**1340-1348 Samford Road & 25, 47, 47A, 47B
Conavalla Street, Ferny Grove QLD 4055**

Request to Change a Development Approval under Section 81 of the
Planning Act 2016: Development Permit – Material Change of Use
(Council Reference: A006124979)

On behalf of
HDM Ferny Grove Pty Ltd

Minor Change Application

Figure 3 Approved Level 01 Plan

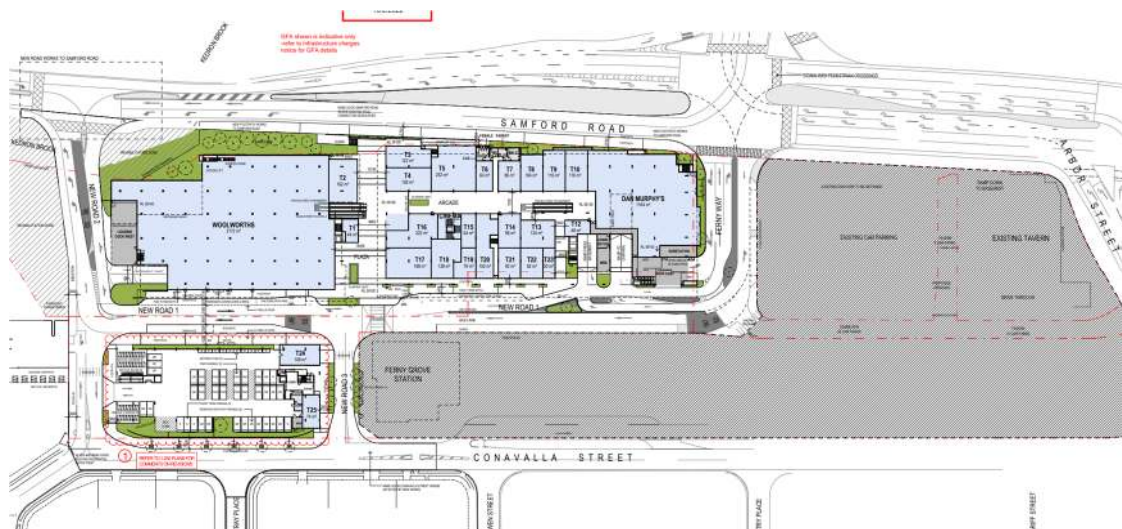
The proposed *Level 01 Key Plan* from the current approval (A006124979) is illustrated in **Figure 3** below.

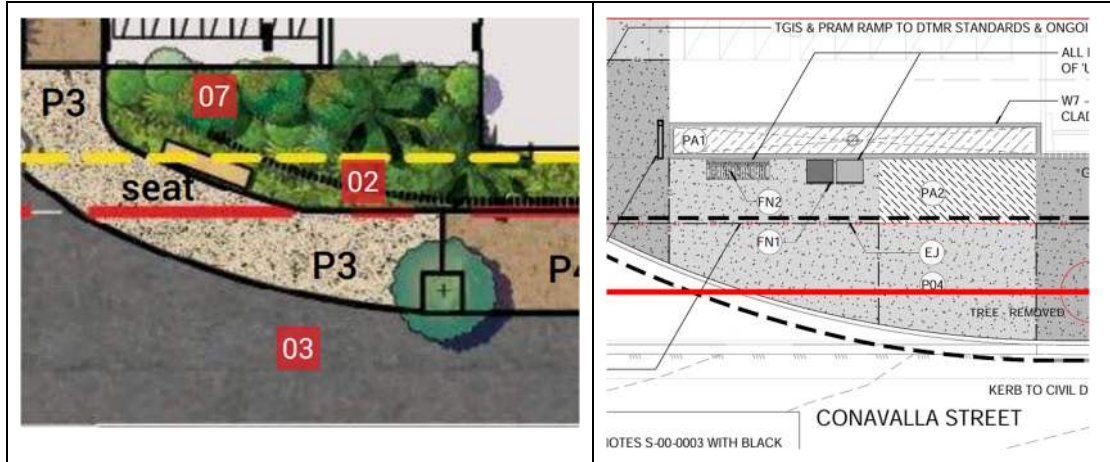
The proposed changes to the three (3) refuse storage areas, including size, shape and location, have typically increased capacity while retaining proximity to the RCV standing area. The proposal also involves minor amendments to the locations of the garbage chutes (no changes in size). The adjustments to the waste management arrangements are deemed suitable for the development and are not anticipated to adversely impact the development in accordance with the approval.

While minor changes to the location or classification of transport infrastructure have occurred, the minimum requirements for accessibility, supply and design are retained. The end user experience for each movement to, from or within the site is also largely unchanged, and in many instances improved. There is no net increase in traffic associated with the proposed development.

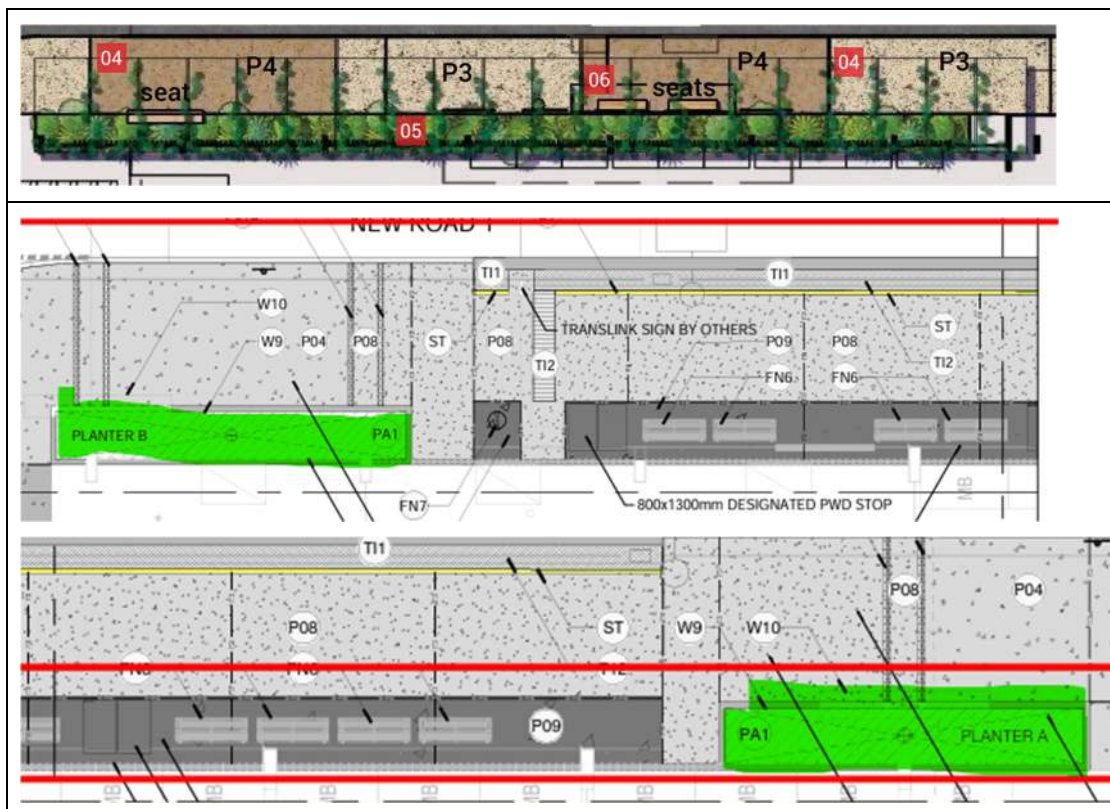
The builder has been in consultation with Thomas Jonker (BCC) as part of the completion of site works. As part of these engagements, it was agreed that two minor departures from the approved landscape concept plans would be resolved via a Minor Change. The changes are in two locations. In the Southwest corner of the Residential Building (Building C) minor changes occurred to the planter box configuration.

Along the Northern Elevation of the Residential Building (Building C) the full-length planter box in the car park has been removed and replaced with two new planter boxes detailed on the pathway.

The updated Architectural package attached under Appendix A illustrate that the changes have resulted in the stamped Landscape Concept Master Plan – Page 11 of 30 being replaced by the Vee Design Drawings C-30-0101 and C-30-0102.
